PUBLIC INTEREST REVIEW FOR GROUNDWATER APPLICATIONS

TO: Water Rights Section Date September 12, 2025
 FROM: Groundwater Section J. Hackett
 Reviewer's Name
 SUBJECT: Application G- 18771 Supersedes review of August 12, 2025
 Date of Review(s)

A. GENERAL INFORMATION: Applicant's Name: Crum Ranch, LLC County: Gilliam

Figure 1. Well Location Map

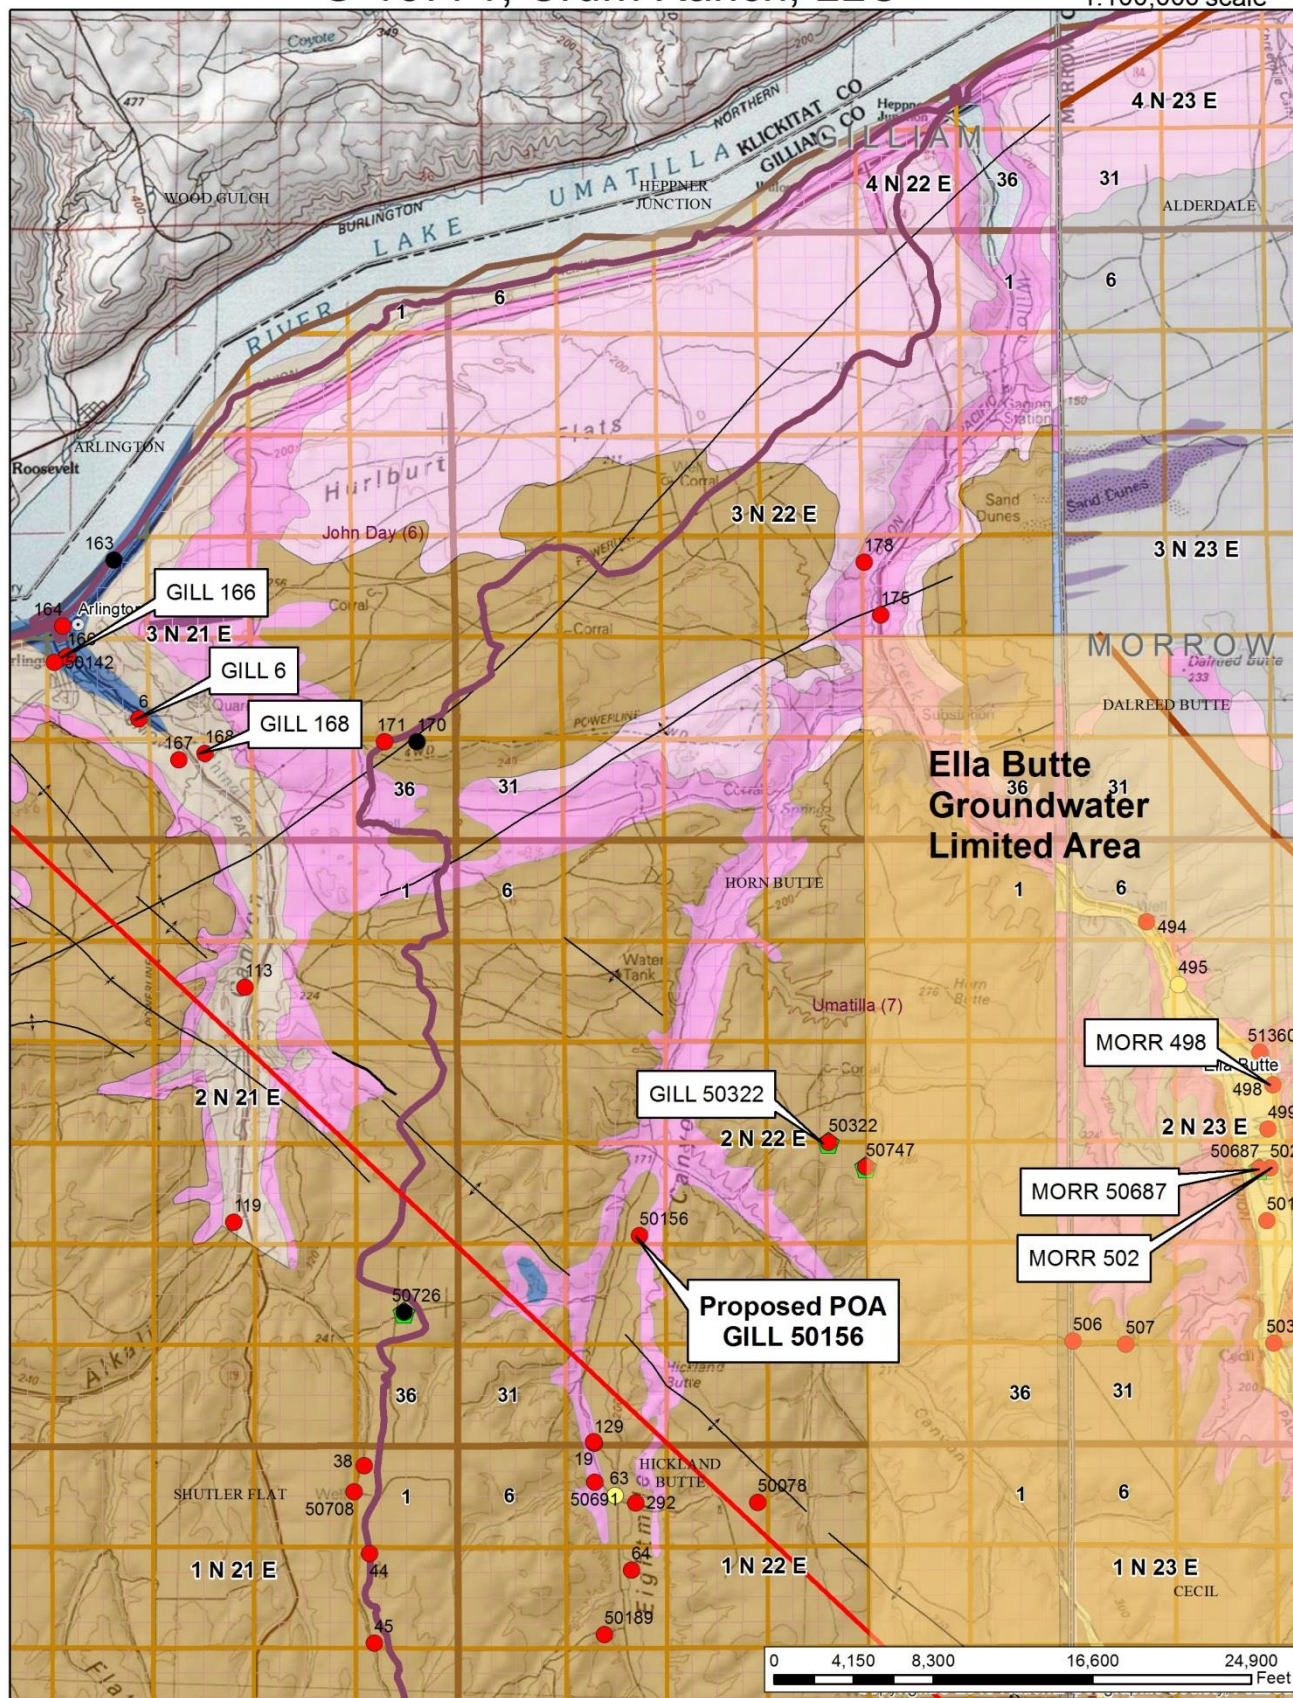
Long-term water level trends in nearby wells are presented in Figures 2 and 3. Well locations are shown in Figure 1. In the applicant's well, water levels have declined 14.7 feet since 2010 (rate of 1.6 feet per year) (Figure 2). (JTI, 8/15/25, updated look at GILL 50156 Hydrograph shows wls have declined 34.3 feet from 2010 to 2025, averaging 2.3 feet per year.) Water level elevations in the applicant's well are very similar to water levels in City of Arlington wells (Figure 2). Water levels in Arlington wells rose about 80 feet in the late 1960s in response to construction of the John Day Dam and consequent rise in elevation of the John Day pool behind the dam. Water levels remained stable from the late 1960s until the mid-2000s. Since the mid-2000s, however, water levels in these wells have declined by 15-20 feet, a rate of 1.5-2.0 feet per year (Figure 2).
